Our File: AVE 866.11

Subject: Site Plan Site 3, Phase 2 of the National Capital Business Park, 4055 Russell Road, Ottawa, and review of previous associated EIS recommendations

Revised Plan for Site 3 Phase 2

Figure 1. A) Site conditions pre-development. B) Current site conditions.

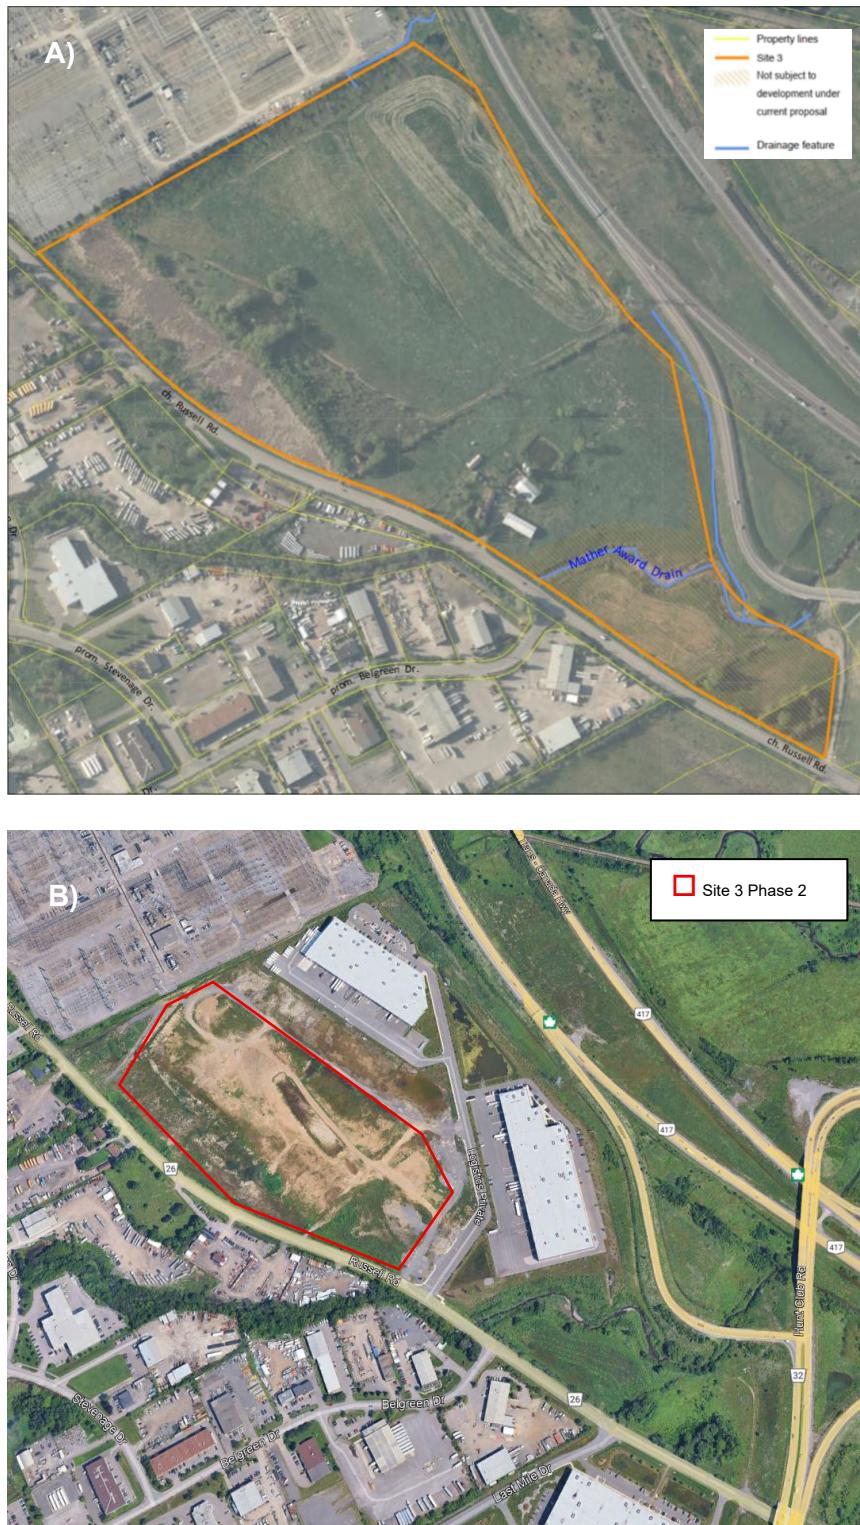
1. *An Environmental Impact Statement was submitted at Phase 1 of this development and handled all relevant environmental concerns. Staff do not object to the findings of this report, but the field work is now out of date.*

A revised EIS must be submitted that includes new field work (species-at-risk screenings being the most pressing matter), as well as updates to the Site Plan and Landscape Plan.

The original site plan for the area north of the Mather Award Drain (i.e. addressing Buildings A1, A2, and B) was supported by the KAL (2021; Appendix 1) update memo rather than a fully revised EIS. That memo identified at the time the absence of SAR and SAR habitats, thereby supporting the full removal of all features providing even *potential* as wildlife habitat north of the Mather Award Drain through the regrading process. With the A1/A3 building site (i.e. Site 3, Phase 2) fully regraded and prepared for construction, it is our professional opinion that the potential for SAR presence there is negligible.

The Master-level EIS (KAL, 2020) did indicate potential for Barn Swallow (*Hirundo rustica*) in the area, but the subsequent KAL (2021) memo found no presence of the species. Given the degree of site clearing, the species is still considered most likely to be absent. However, that species was subsequently downlisted in Ontario to Special Concern status and is thus no longer subject to protection as a SAR under the *Endangered Species Act*, regardless.

Further SAR field studies may be warranted in relation to plans for building E (i.e. where some semi-natural land cover still exists), but no such studies are warranted north of the Drain, as no habitat potential remains.

1
L.1 LANDSCAPE PLAN
SCALE 1:100

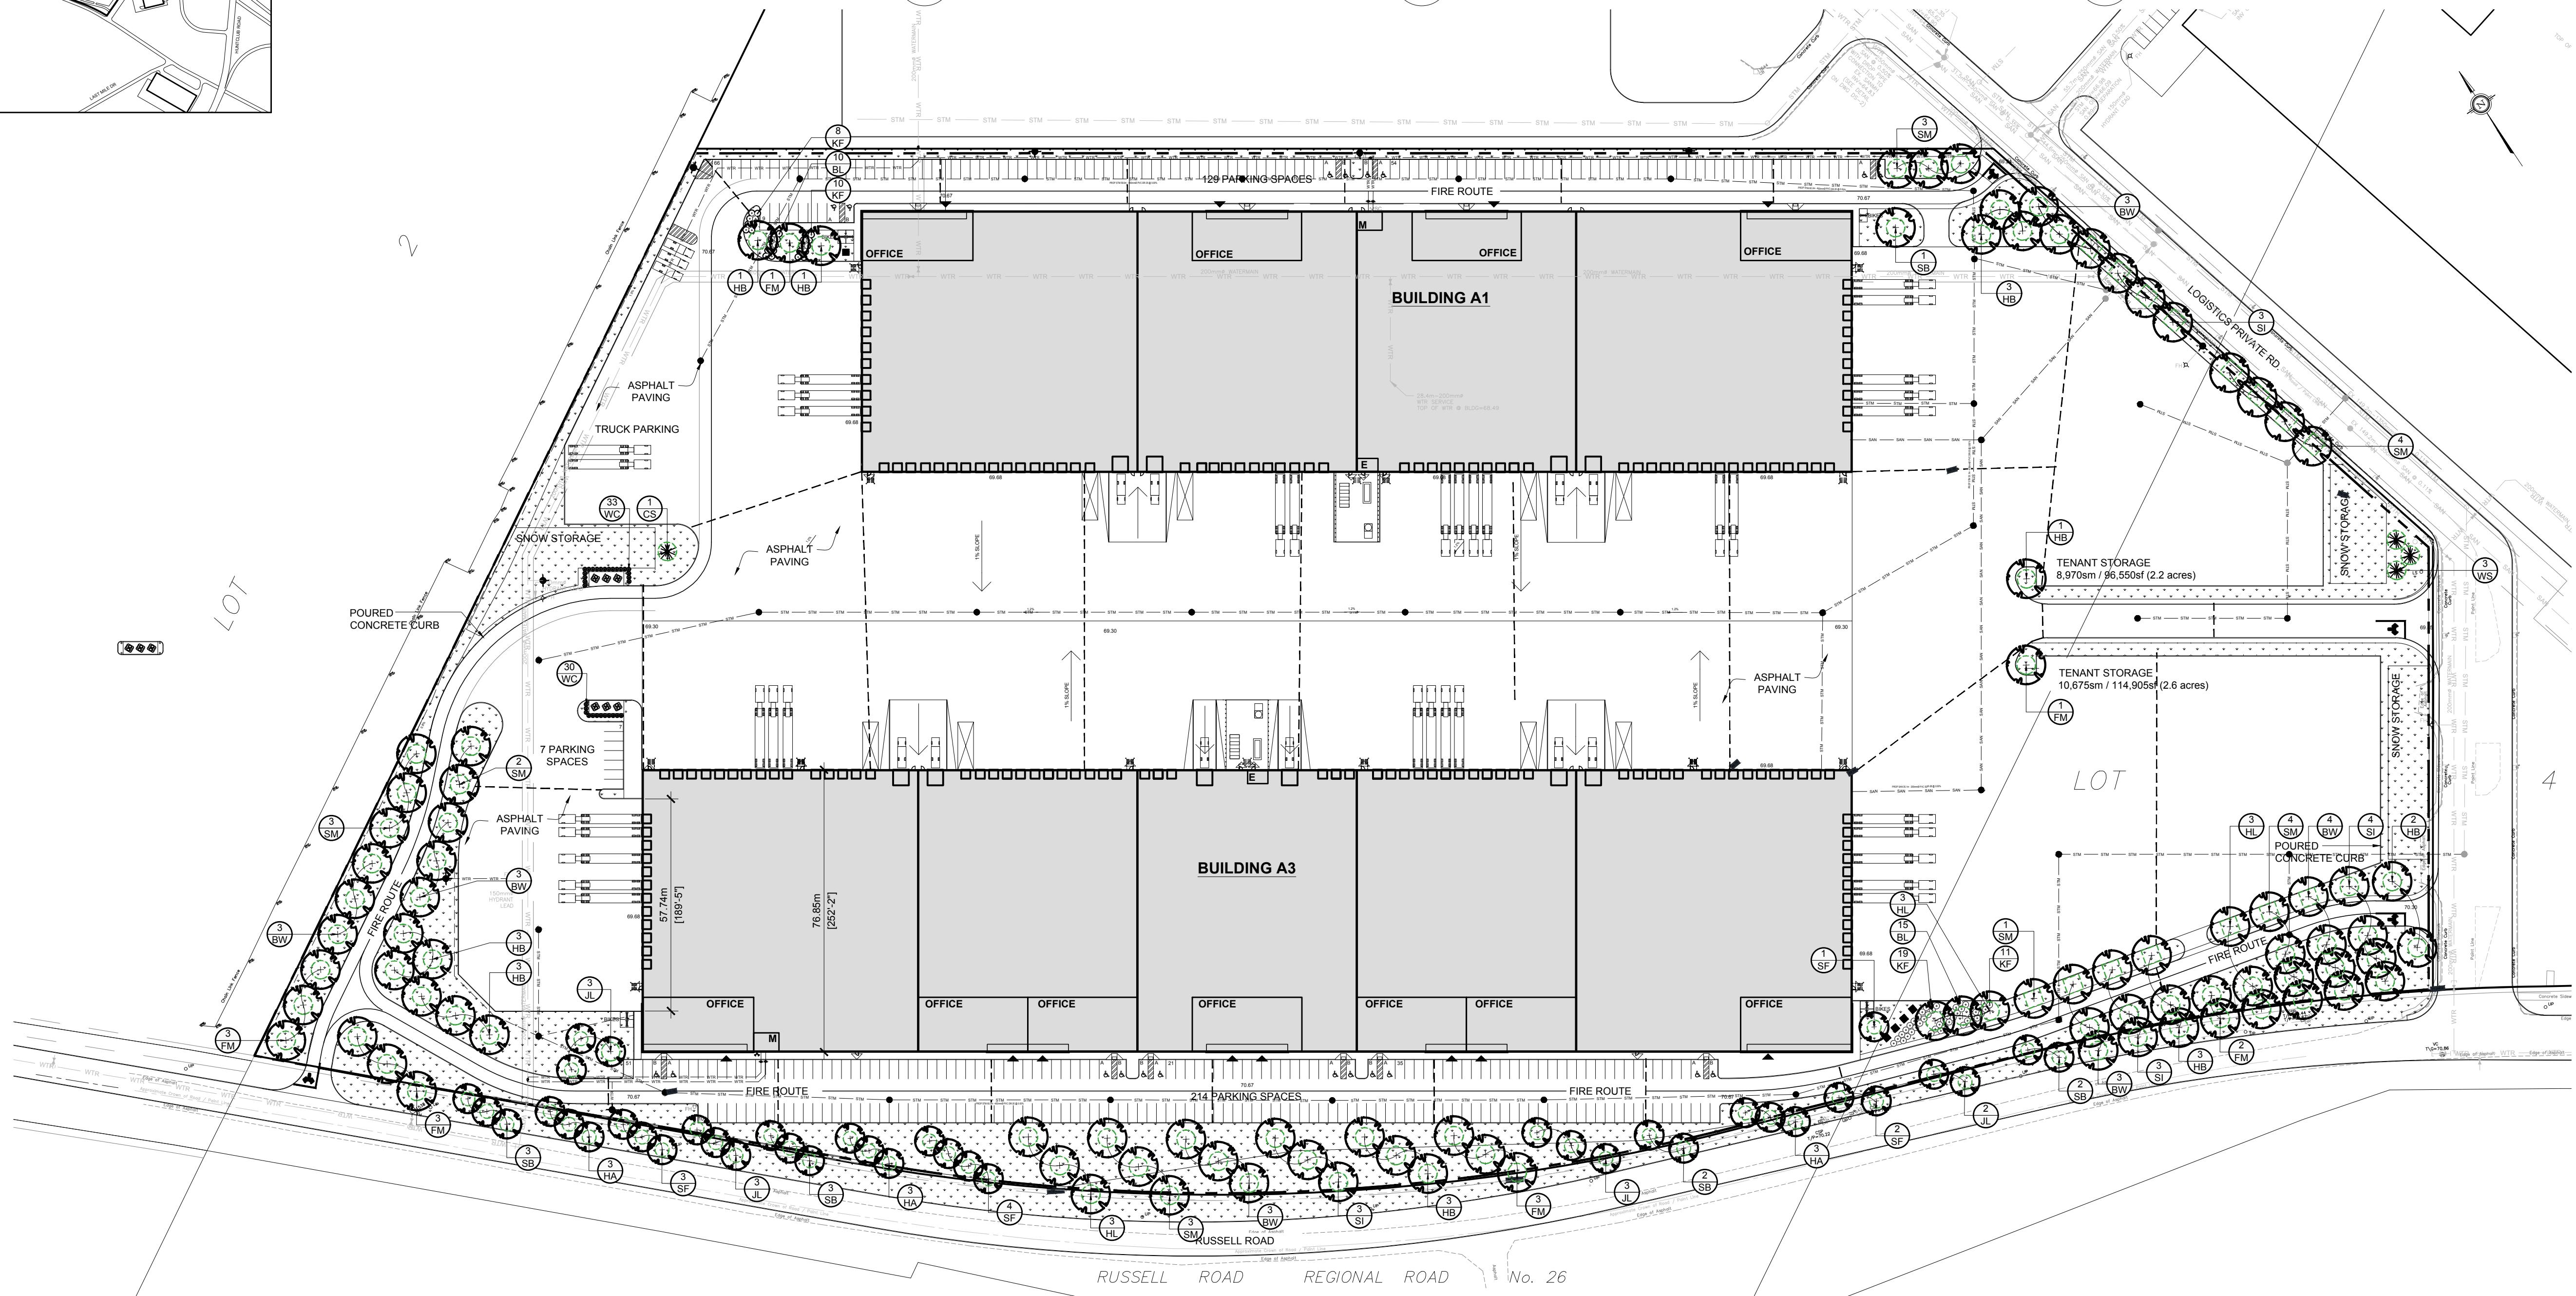
2. *A Landscape Plan was submitted as part of the Phase 1 application, but it did not include the Phase 2 lands. A Landscape Plan that includes reforestation between the development and the watercourse must be submitted. The landscaping on the other side of the drain, for Phase 1, would be a good guide for the extent of plantings expected on this site.*

This memo, effectively serving as an EIS, agrees with this requirement. It is our understanding that the Landscape Plan for Phase 2 (i.e. the Building A1/A3 area) will include tree planting within the Mather Award Drain Corridor. As a "Drain", however, one side of that watercourse must generally remain accessible to allow maintenance work within the channel when and as required. Tree planting must be primarily focused on one bank. The potential for thermal regulation of the watercourse with shading from riparian trees is generally maximized by trees along the south bank. Accordingly, most tree planting within the Mather Award drain riparian corridor should be managed in association with site planning for the future Building E development.

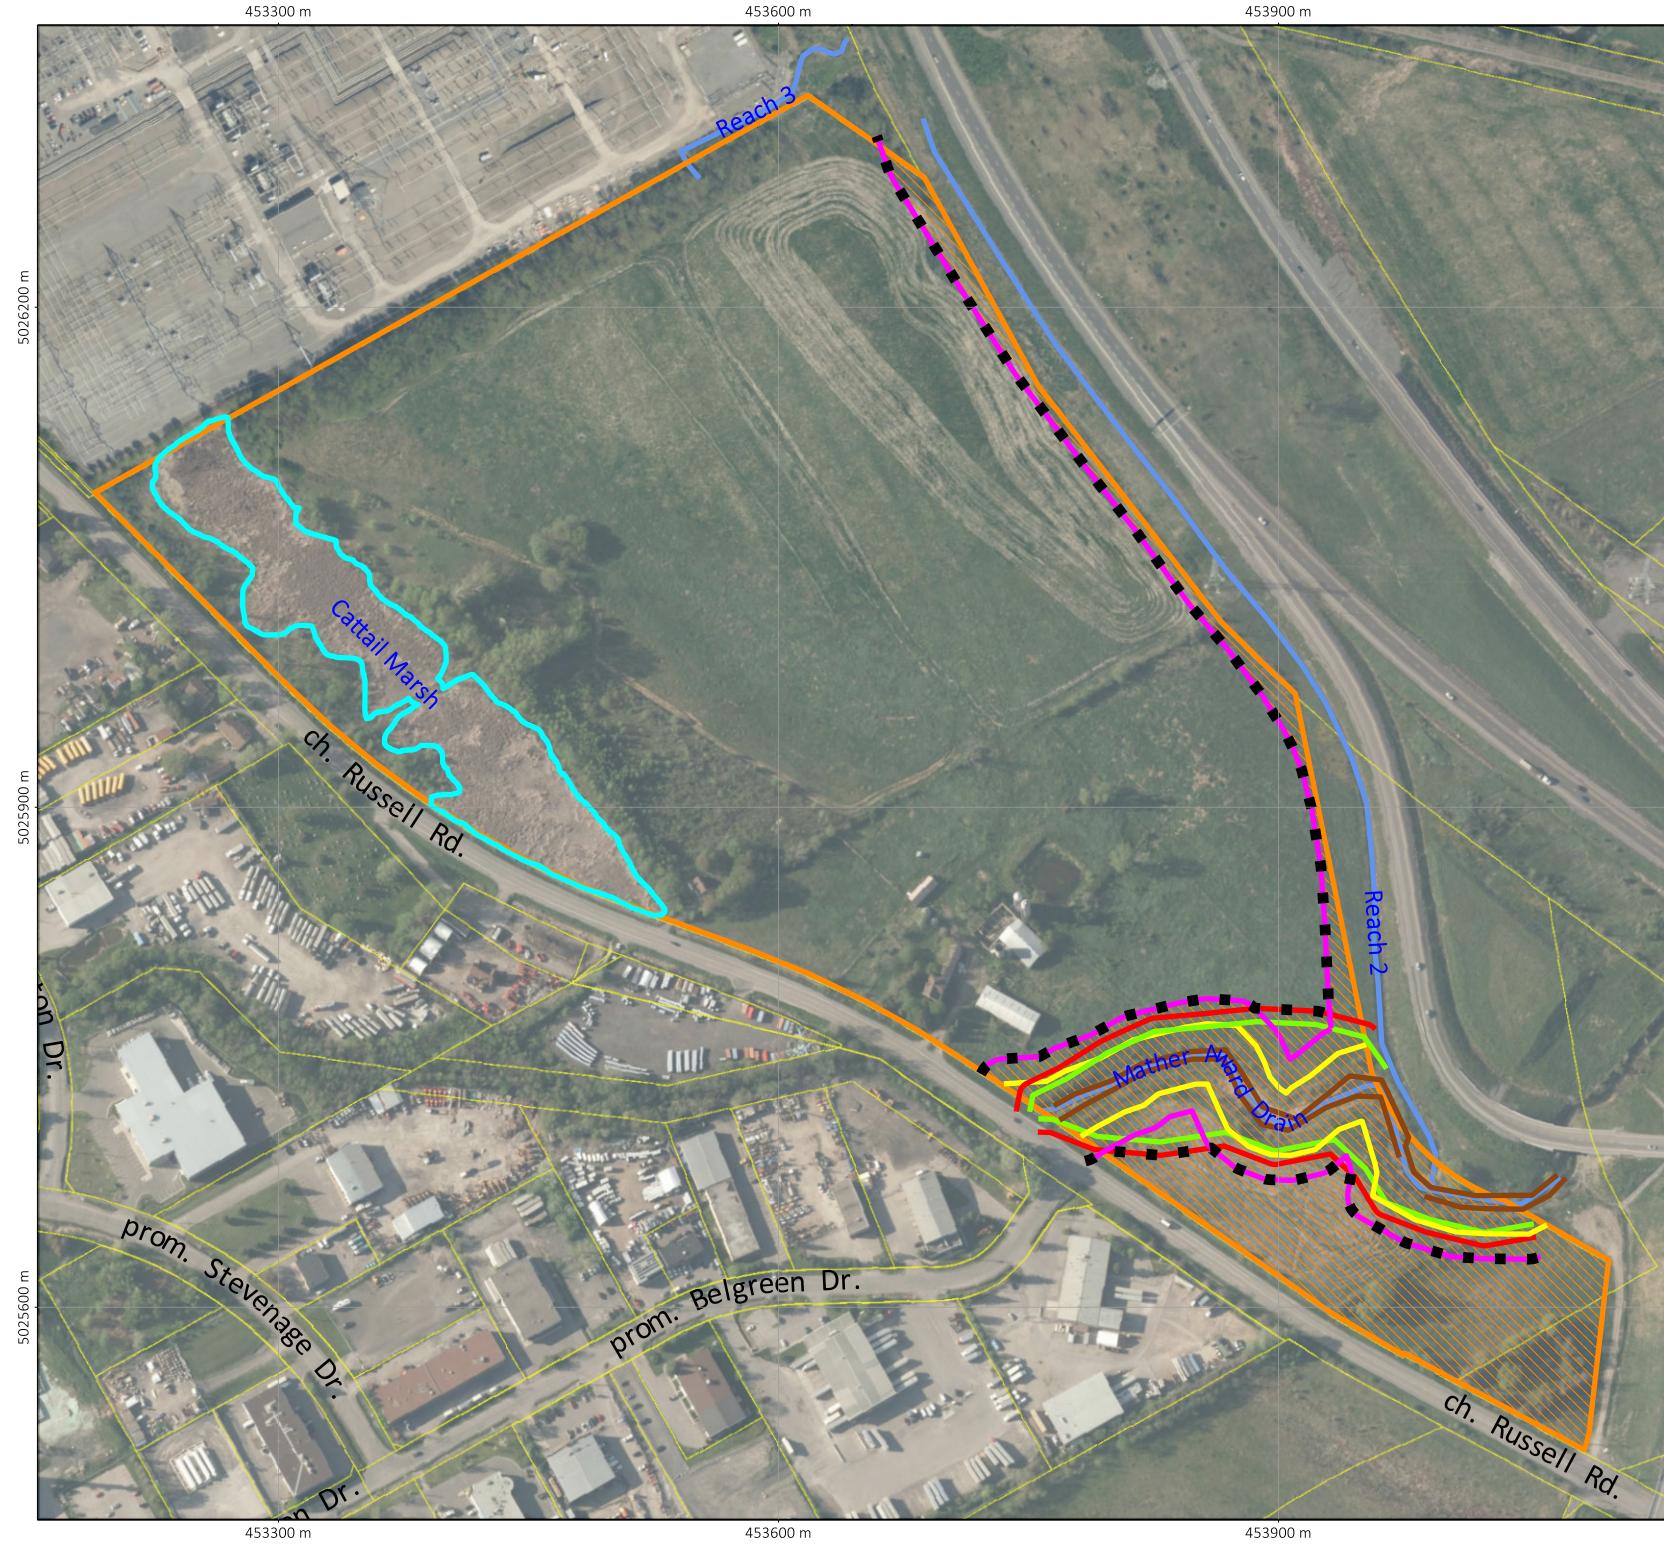
It is not clear on the plans provided what watercourse setback is being provided for Reaches 1 and 2. A site plan clearly identifying the 30 metre setback from the normal highwater mark for Reaches 1 and 2 (as identified in the Kilgour & Associates report) is required. The plan should also include the limit of hazard lands proposed by Paterson Group.

Based on the landscape package, there is a crossing proposed on the Mather Award Drain. No details on this proposed crossing were provided. If a crossing is going to form part of this submission, then details on the watercourse crossing are going to be required which may include engineering drawings and a hydraulic analysis. It is recommended that the applicant consult further with the RVCA on these requirements prior to initiating any studies.

- Please see Figure 3 below.

- The current proposed site plan does not include a crossing over the Mather Award Drain. AVENUE31 will consult further with RVCA and the NCC if they plan to pursue such a design feature.
